Australian Air Publication 721.79

ROYAL AUSTRALIAN AIR FORCE

VAMPIRE MODIFICATIONS

(Nos 1 to 100)

DE HAVILLAND DRG No. OOM 203 SHT 1 No. OF SHTS 1

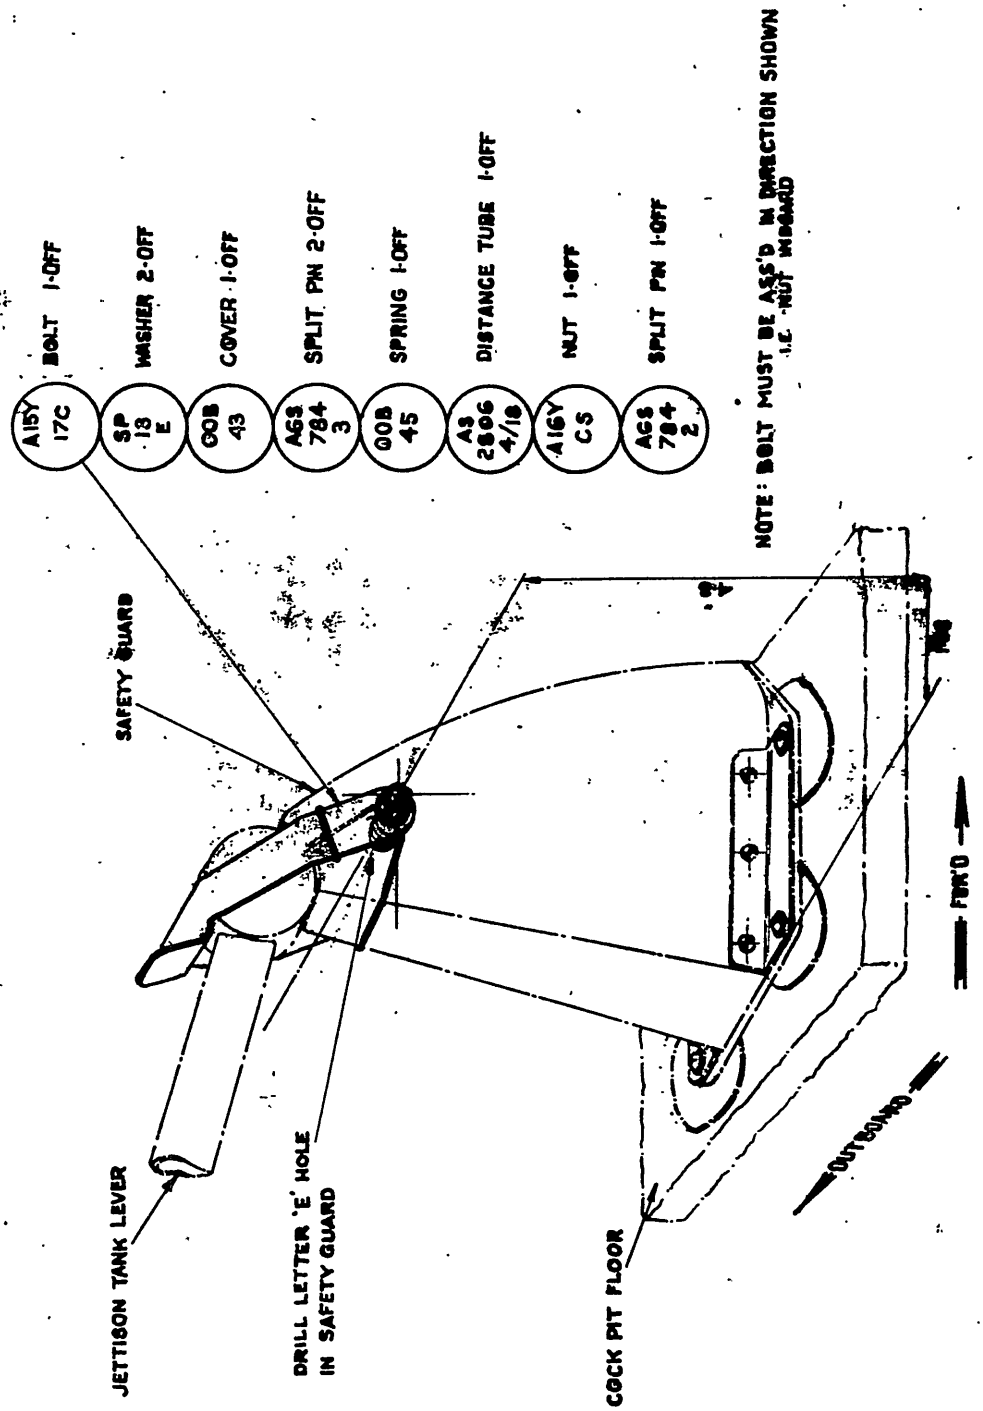
8. Refer drawing A.11756 and drill a letter E hole through the guard in accordance with the dimensions shown.

REFERENCE	ISSUED BY	
	DIRECTORATE OF TECHNICAL SERVICES	LANDING WHEEL – LOCK RING
	R.A.A.F.	WIRE LOCKING
		UNDERCARRAGE
		VAMPIRE MK 30
		NENE 2VH
		VAMPIRE MOD 58
	L.M.R.	A-11765

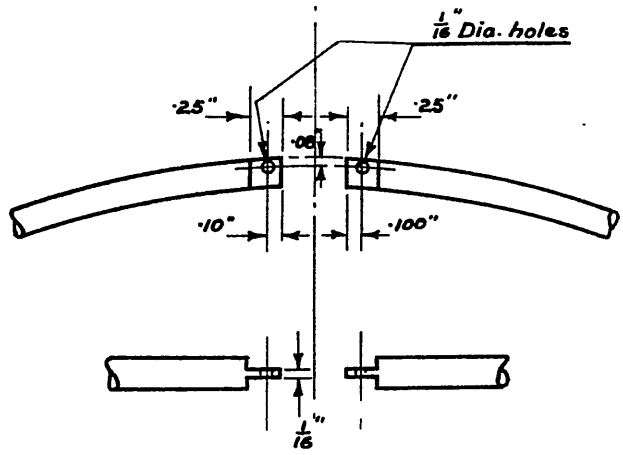
9. The two ends of the lock ring are to be worked so as to provide a lug at each end of the lock ring as shown in drawing A.11765.

PLAN VIEW SHOWING ARRT OF G3F COMPASS DETECTOR UNIT IN STARBOARD WING
(TOP SKIN REMOVED)

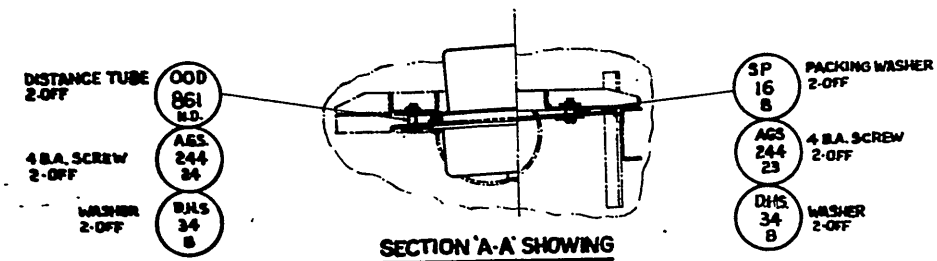
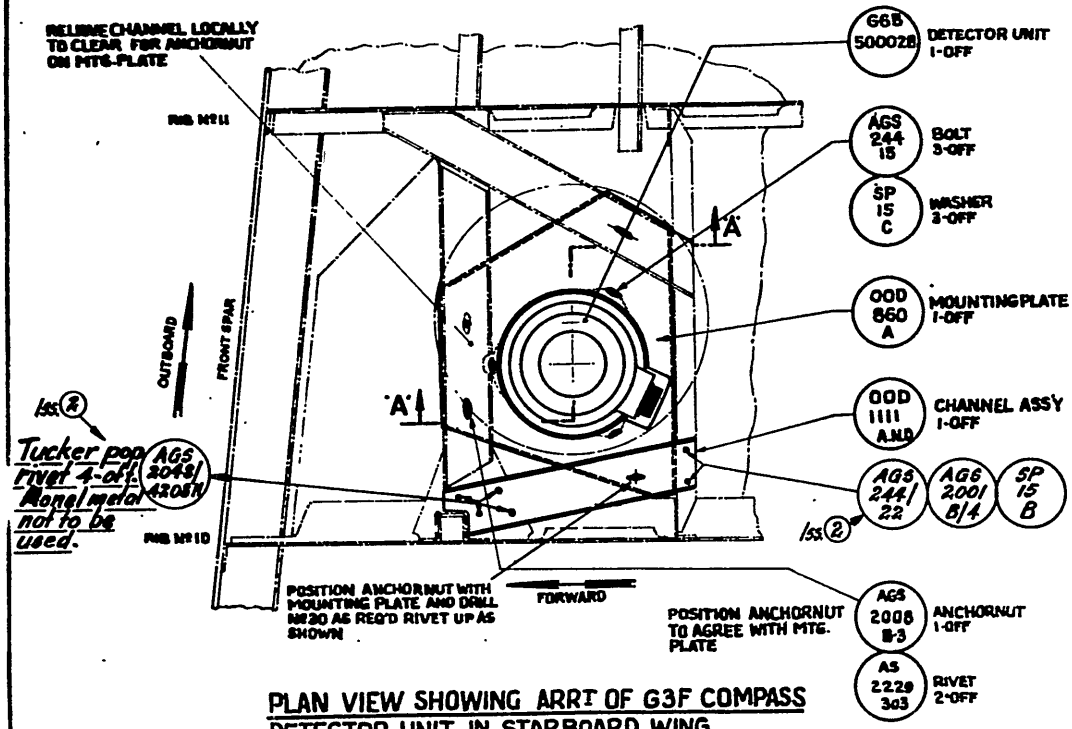
58. Refer drawing A.12138, sheet No.1 and carefully drill out the ~~six~~ Four rivets (item 133) holding the channel assembly (item 112) to the mounting structure.

SECTION 'A-A' SHOWING ATTACHMENT OF MTG. PLATE TO STRUCTURE

DE HAVILLAND DRG Nº 00M216 SHEET Nº 2 Nº OF SHEETS 6

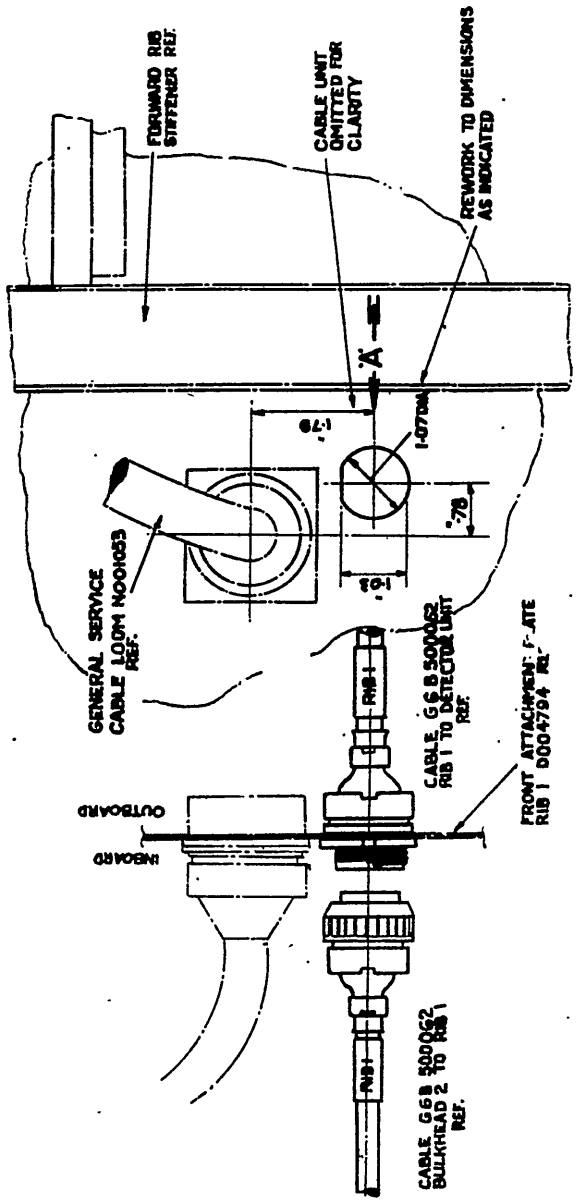
66. Refer drawing A.12138, sheet No.2. Rework the 25/32 inch hole in the front plate of rib No.1, provided for the original cable run, to the dimensions shown.

109. Rework the 25/32 inch hole in rib No.1 to drawing A.12138, sheet 2 and attach the coupler socket in the hole in accordance with paragraphs 66 and 67. Connect both cables together.

VIEW SHOWING ATTACHMENT AND REWORK ON RIB 1 STARBOARD

DE HAVILLAND DRG. Nº 00 M 216 SHEET Nº 3 Nº OFF SHEETS 8

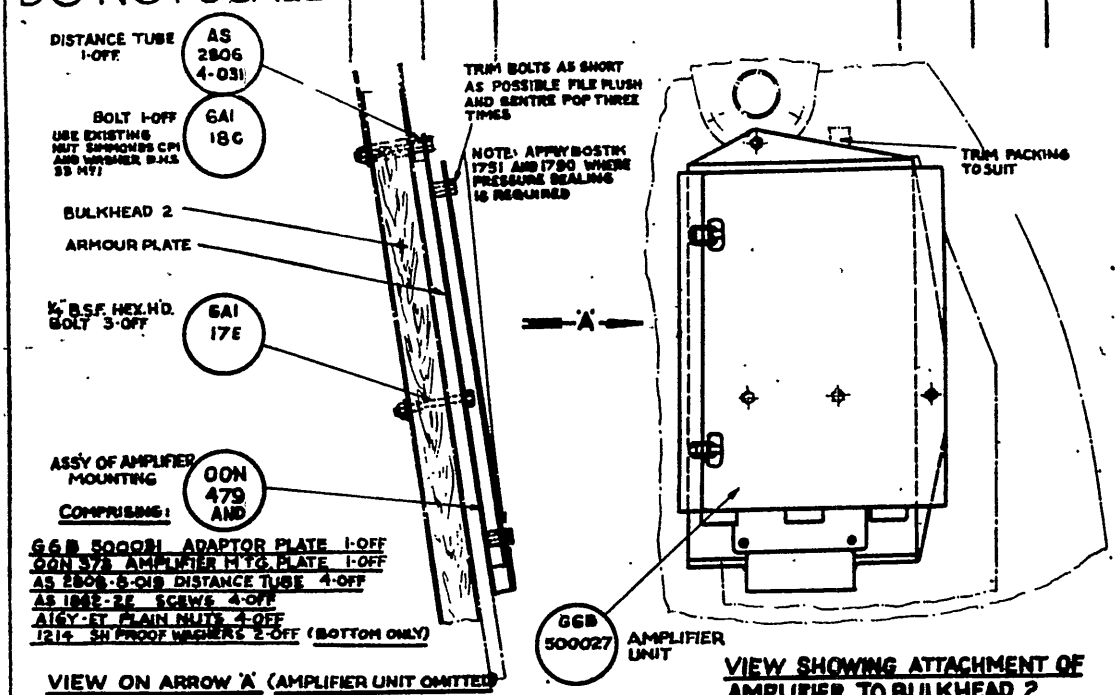
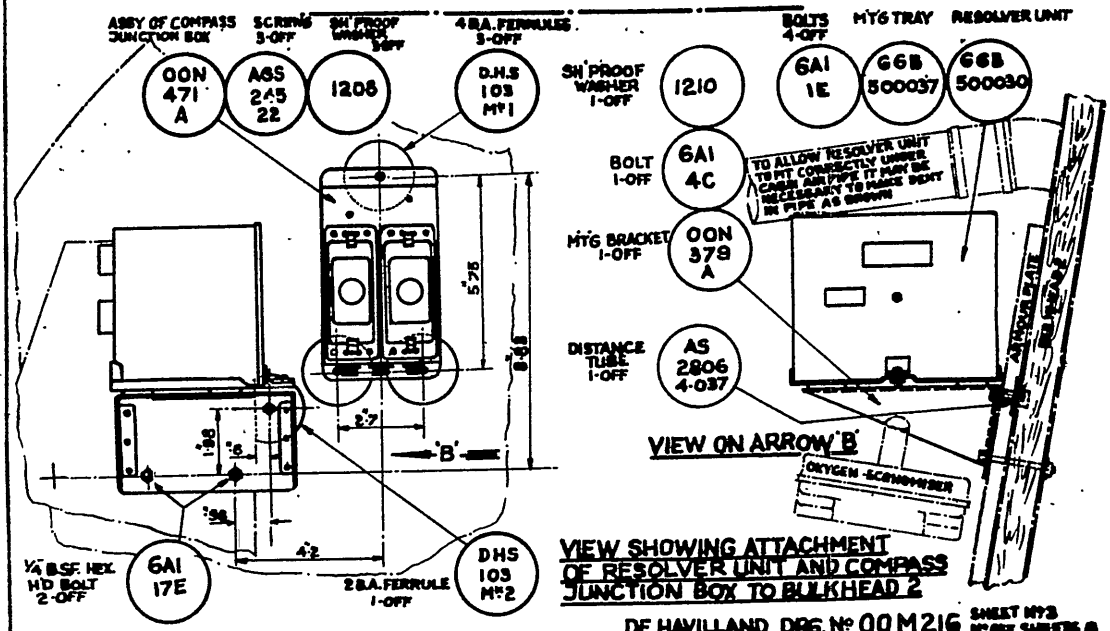
43. Refer drawing A.12138, sheet 3 and position the new 2 BA ferrules (item 43) and the three 4 BA ferrules (item 42) on the forward face of bulkhead No.2 in accordance with the dimensions shown. Trim the 2 BA ferrule to suit the armour plate.

VIEW SHOWING ATTACHMENT OF AMPLIFIER TO BULKHEAD 2

DE HAVILLAND DRG No 00M216 SHEET No 4 No OF SHEETS 6

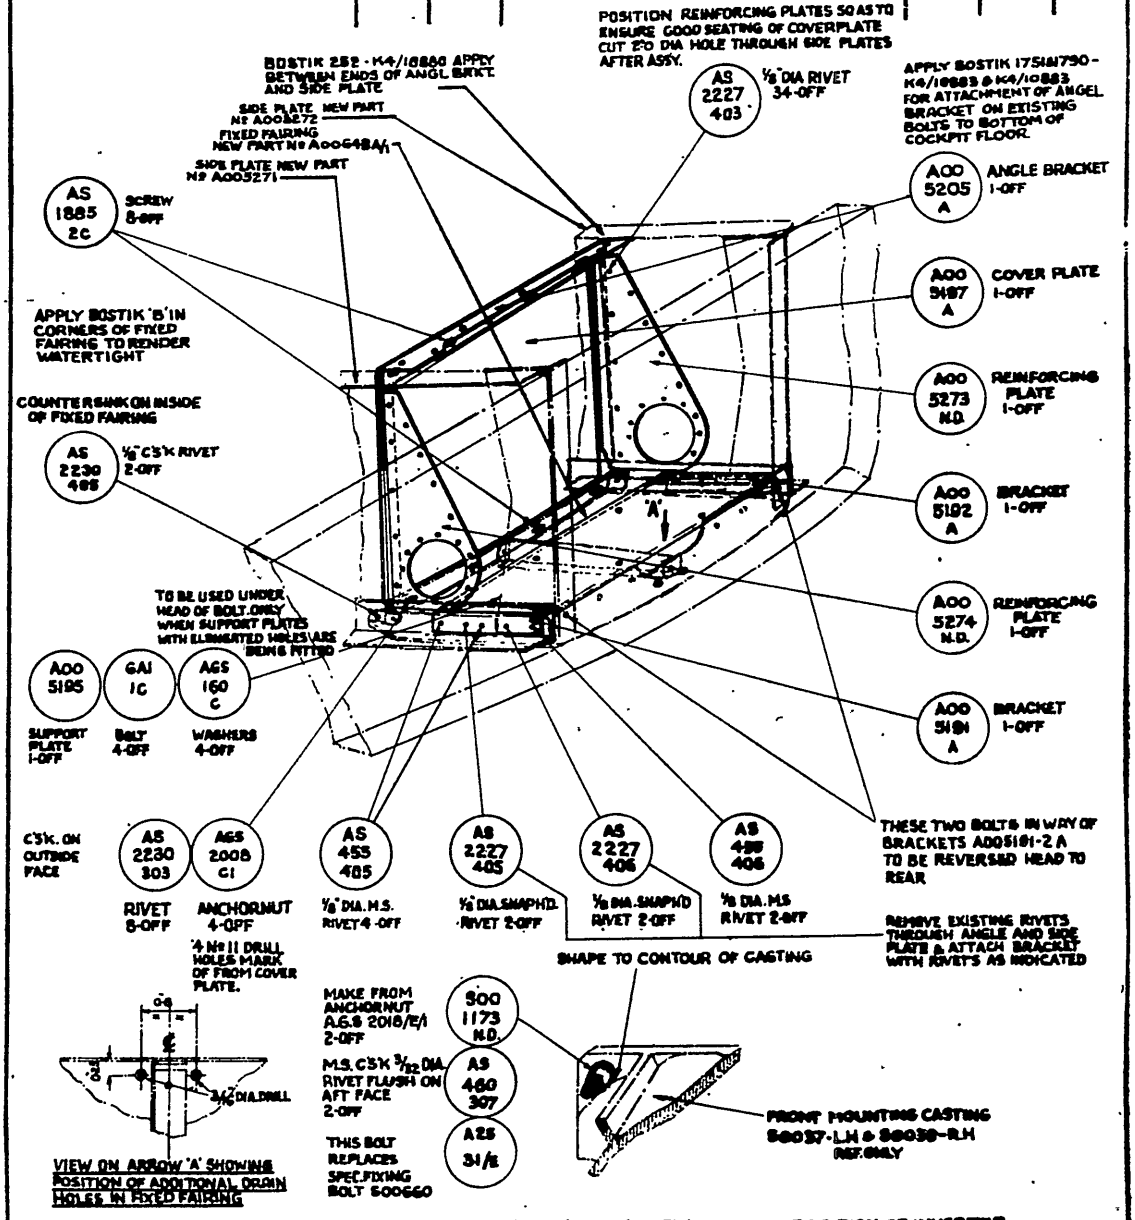
8. Refer drawing A.12138, sheet No.4. Locate the fixed fairing aft of the nosewheel door and attach the top angle bracket (item 16) to the cockpit floor, in the position shown, with the six existing bolts. Apply Bostic 252 - K4/10880 between the ends of the angle and the side plates and Bostic 1790 & 1751 (K4/10882-3) to pressurise.

ISOMETRICAL VIEW SHOWING POSITION OF INVERTER OF G3F COMPASS IN NOSE WHEEL HOUSING

DE HAVILLAND DRG Nº OOM216 SHEET Nº 6 Nº OF SHEETS 8

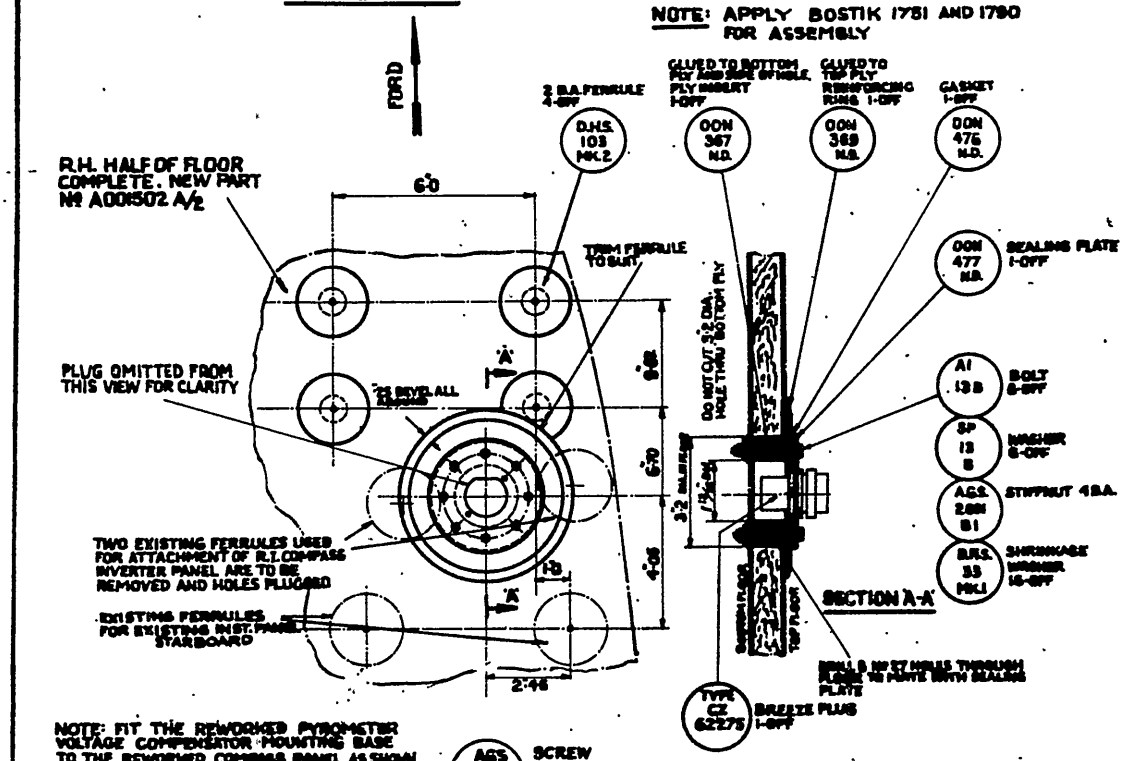
24. Refer drawing A.12138, sheet No.6 and drill four No.11 holes in the voltage compensator base plate as shown. Alter the Part No. of the assembly B00707AND to read 00N440AND and mount the reworked compensator on top of the new G3F compass control panel (item 53), using four bolts (item 5) and four washers (item 80).

25. Refer drawing A.12138, sheet No.6 and position the four new ferrules (item 43) to agree with the dimensions shown therein. Remove the two existing ferrules (item 123) in the way of the hole as shown on the drawing. Plug the holes. Drill a hole 1.13/16 inch through the cockpit floor. Cut away the top ply and balsa wood around the hole until a 3.2 inch diameter is obtained, but leave the bottom ply. Fit the ply insert ring (item 45) in the hole and glue it to the supporting bottom ply and the sides of the hole. Position the reinforcing ring (item 1) over the ply insert ring and glue to the top skin.

PLAN VIEW OF COCKPIT FLOOR SHOWING POSITION AND REWORK FOR G3F COMPASS CONTROL PANEL AND PRESSURE SEAL FOR INVERTER CABLE

NOTE: APPLY BOSTIK 1751 AND 1780 FOR ASSEMBLY

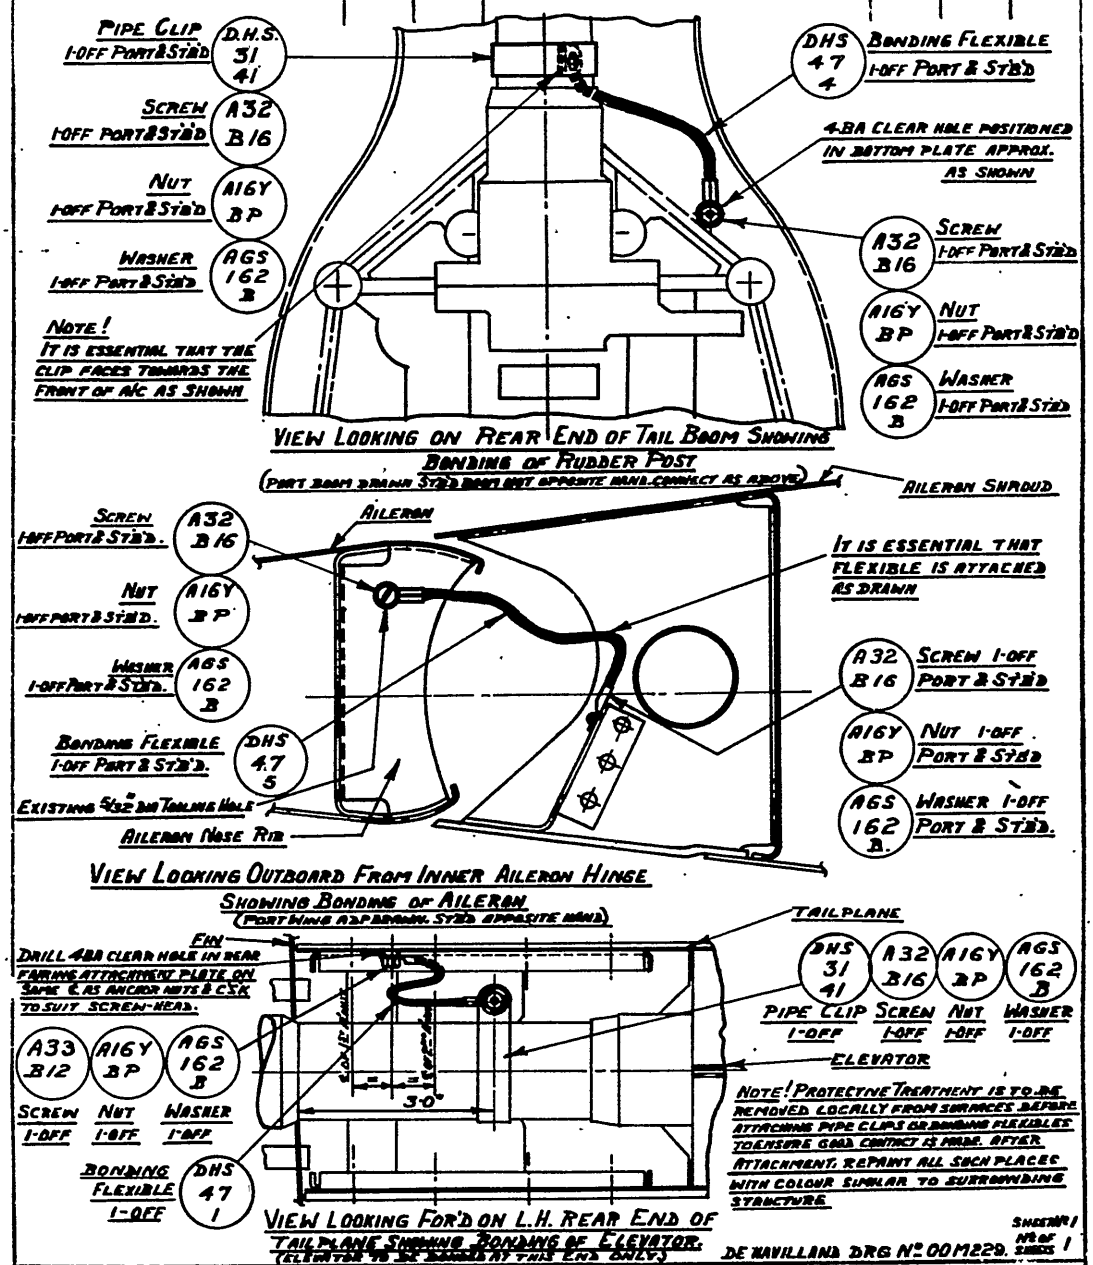
(c) Refer drawing A11919. Attach a pipe clip (item 4) to each rudder post in the position shown, so that the clip faces towards the front of the aircraft and then secure the clip using attaching parts (items 5, 6 and 7). Assemble a flexible bonding (item 2) under the head of the bolt.

INVERTED PLAN VIEW OF PORT WHEEL WELL
STARBOARD WING OPPOSITE

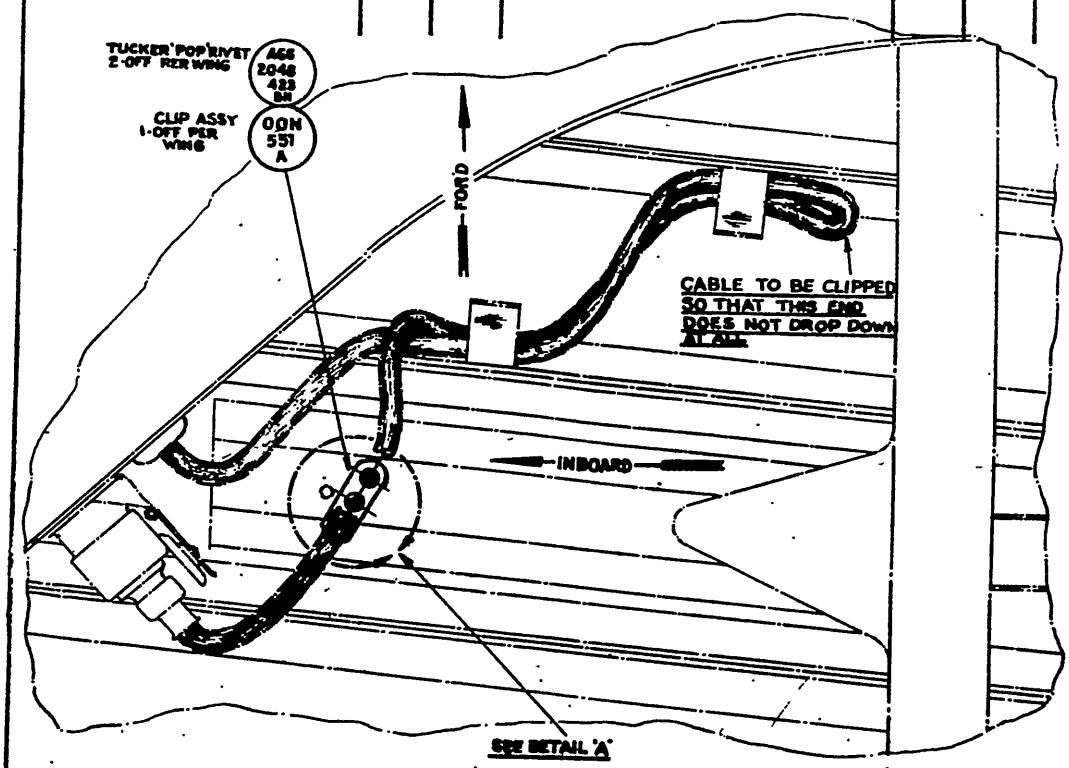
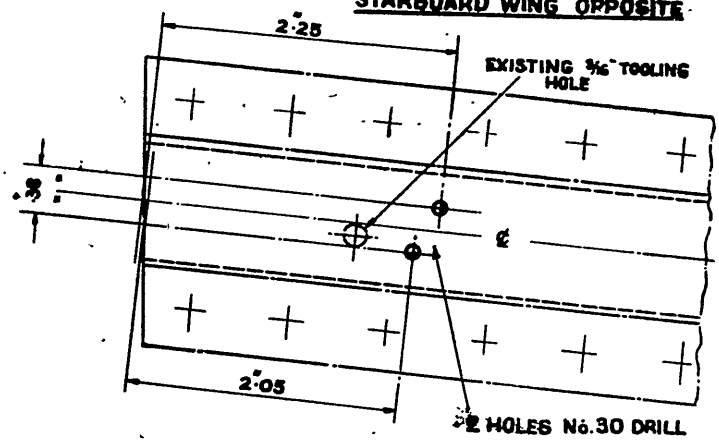
(i) Locate the R.P. cable at the safety break in the port side wheel well. Refer drawing A11924 and drill two holes as indicated using a No.30 size drill.

IMPORTANT: NO NYLEX TO BE FITTED TO THIS CABLE IN THE WHEEL WELL

DE HAVILLAND DRG Nº 00M226 SHT 1 Nº OF SHTS 1

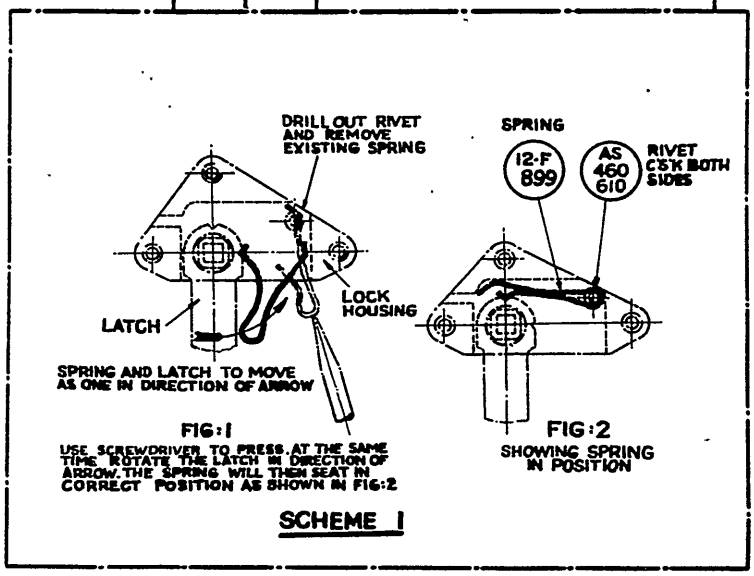
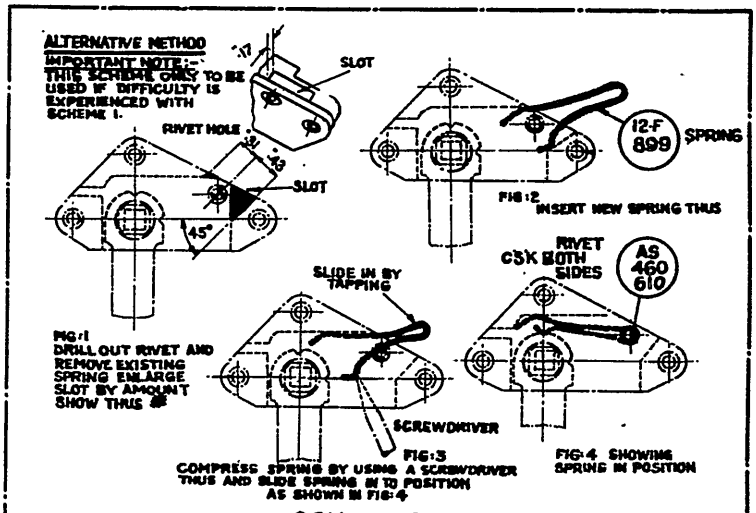
10. Refer drawing A11929, and with the latch in the "down" position, fit the new spring as indicated (item 5).

13. Refer drawing A11929, and file away the portions shown hatched. Clean and remove all traces of fillings.
